P9001A-01

S E R V I C E N O T E

P9001A Agilent P9000 series Massively Parallel
Parametric Test System

Industrial PC requires SATA power conversion cable to replace

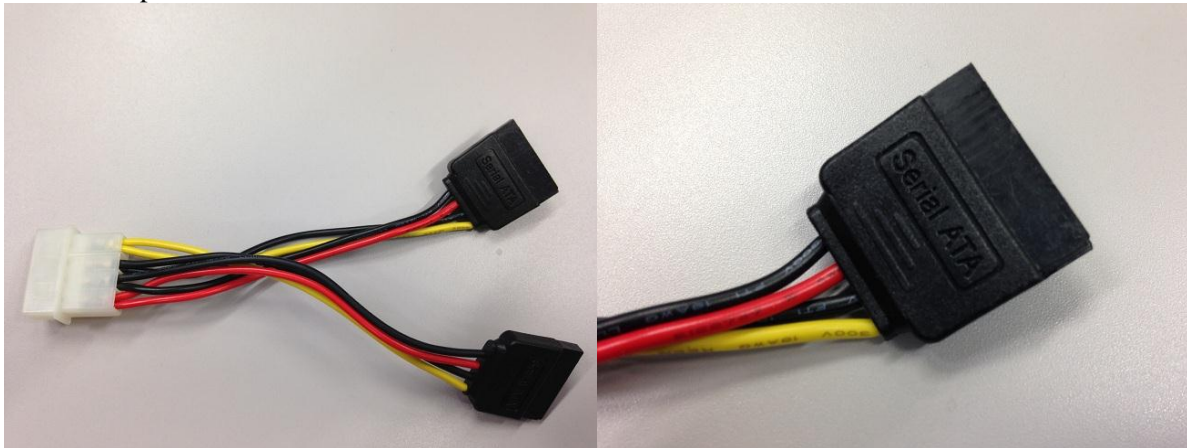
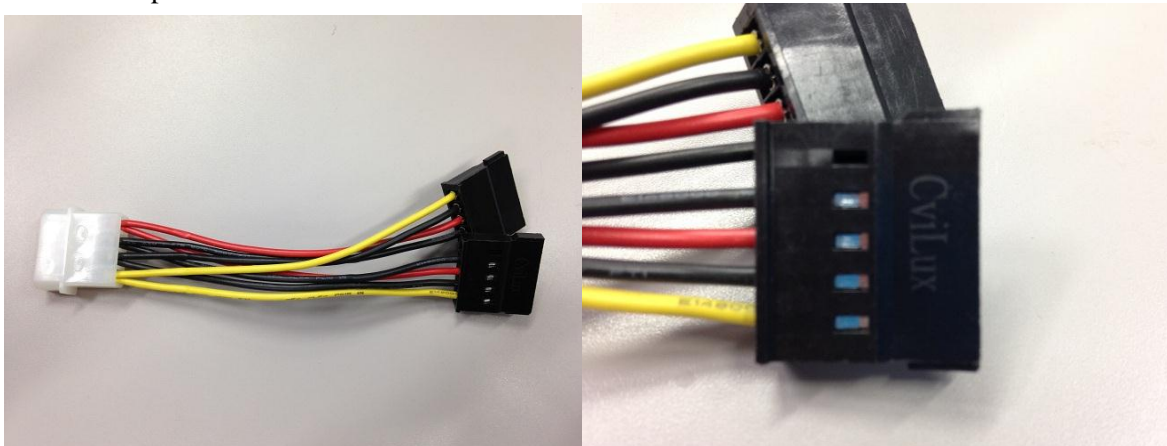
Agilent industrial PC includes SATA power supply conversion cable to connect power supply and HDD. Some IPC may have manufacturing issue at SATA power supply conversion cable, and it may have system fault by power fail.

PN 8121-2648 replacement SATA power supply conversion cable has SATA connector printed as “CvLux” instead old one has “Serial ATA”.

Replace SATA power supply conversion cable on Agilent industrial PC with new one (PN:8121-2648) .
